Access Compliance Report Public Rights-of-Way (RR Crossings)

Intersection ID: 10025341	Main Street: E_7TH_ST	Location: N/A
ADA ID: E6FBB3A68669	Overall Compliance: No	Severity Score: 0.0
Codes/Mitigation Info/Possible Solution		Field Measurements/Component Compliance

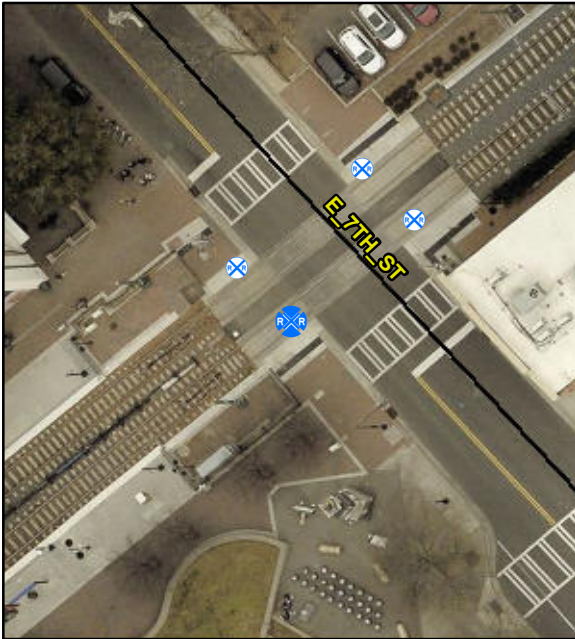
**Remove & Replace Detectable
Warning System. Provide Pedestrian
Gate. Remove & Replace Walking
Surface Adjacent to Rail.**

R302.7.4, R305.2.5

Compliance	Description	Data
Yes	DWS Provided?	Yes
Yes	DWS Contrast?	Yes
Yes	DWS Width (in)	Yes
Yes	DWS Length (in)	24.0
No	DWS Offset (in)	71.0
No	Pedestrian Gate?	No
N/A	DWS Outside Gate?	Yes
N/A	Rail Type?	LightRail
No	Flangeway Gap (in)	2.75
Yes	Sidewalk Width (in)	176.0
